**CITY OF BATON ROUGE
PARISH OF EAST BATON ROUGE
DEPARTMENT OF ENVIRONMENTAL SERVICES**

ADDENDUM NO. 4

SUBJECT: **LOVETT ROAD – GREENWELL SPRINGS ROAD PROJECT
CITY-PARISH PROJECT NO. 10-FM-MS-0049**

F IPS HDPE TO DIP TRANSITION FITTING DETAIL FOR FM SIZES 24" THROUGH 48"
NOTE: ALL BOLTS AND ACCESSORIES TO BE STAINLESS STEEL. N.T.S.

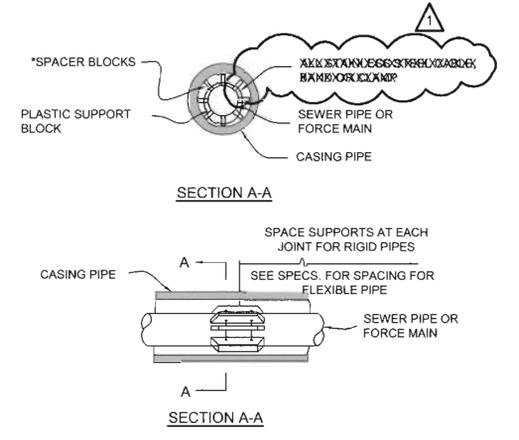
1. Note on 42" HDPE bore says IPS dr13.5, but spec section 1016-2.2B requires DIPS. Either way, the small quantity of DR13.5 required for this project does not meet minimum run requirements for HDPE manufacturers, and it is highly unlikely that another project will require the same to fill out a run. The vast majority of 42" HDPE we see is DR17, which has a 125 PSI rating, but can accommodate an occasional surge of up to 250 PSI

HDPE with a DR of 13.5 is required. The contractor can provide either 42" IPS or 42" DIPS as long as the DR is 13.5.
